<p align="center">Office Action Summary</p>	Application No. 10/605,852	Applicant(s) WEISS, MARTIN	
	Examiner Vinh T. Luong	Art Unit 3682

6. Claims 15-18, 21, and 22 are rejected under 35 U.S.C. 102(b) as being anticipated by Yamashita (US Patent No. 5,946,978).

Fig. 6

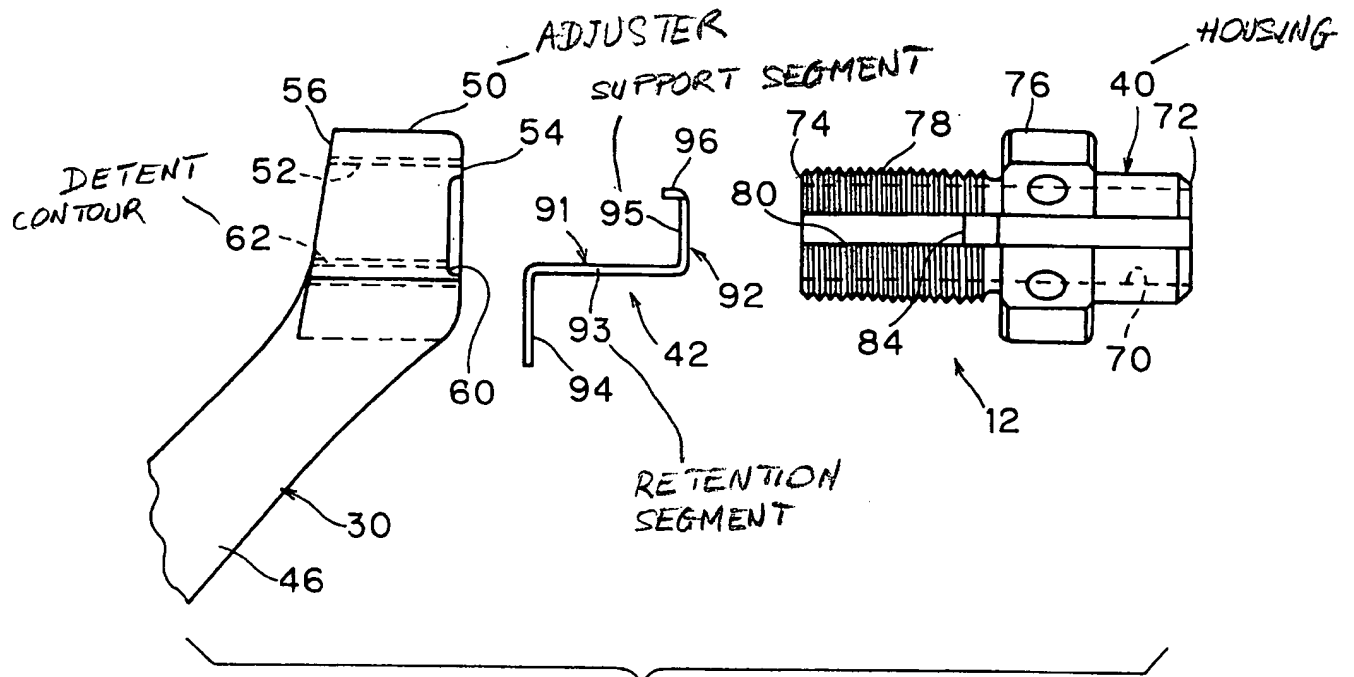
an adjuster 50 (Fig. 6) rotatably connected to a housing 40 of the control mechanism 16 such that the adjuster 50 is axially movable relative to the housing 40 in response to rotation of the adjuster 50; and

Fig. 7

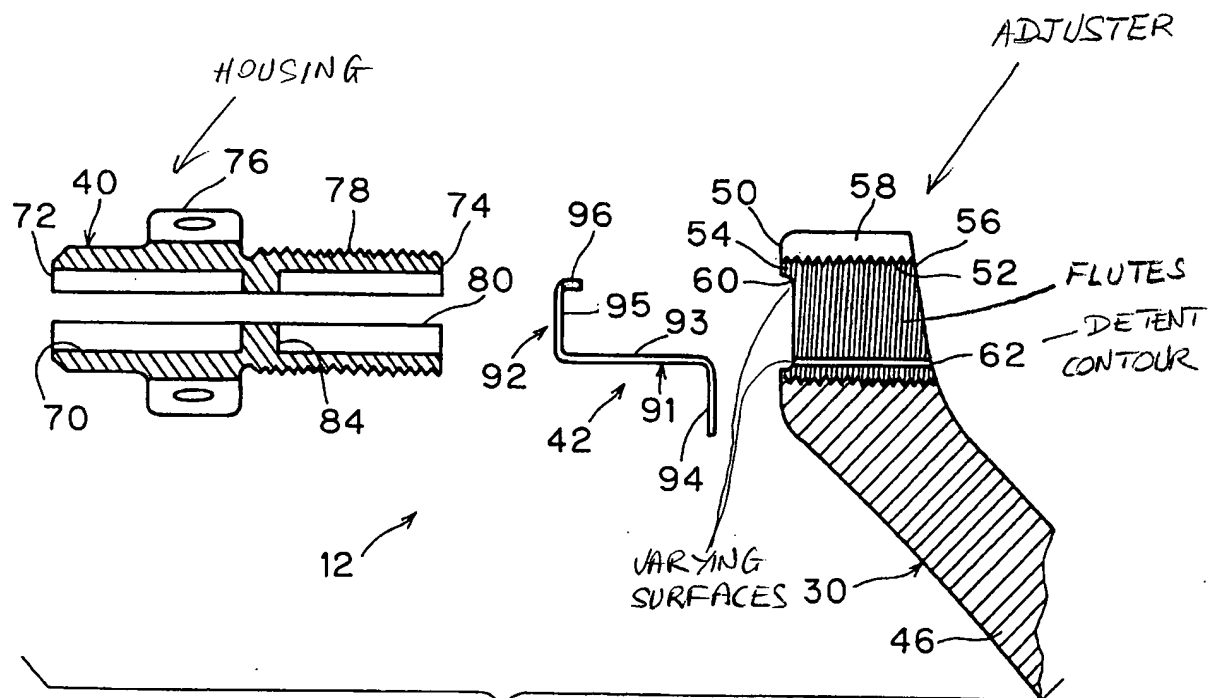
Regarding claim 17, the detent contour 62 includes varying surfaces 60 (Fig. 7, see Attachment) configured to engage the retention segment 93 such that rotation of the adjuster 50 in a first direction requires a higher rotational force than rotation of the adjuster in a second direction. *Ibid.*, col. 6, lines 24-64.
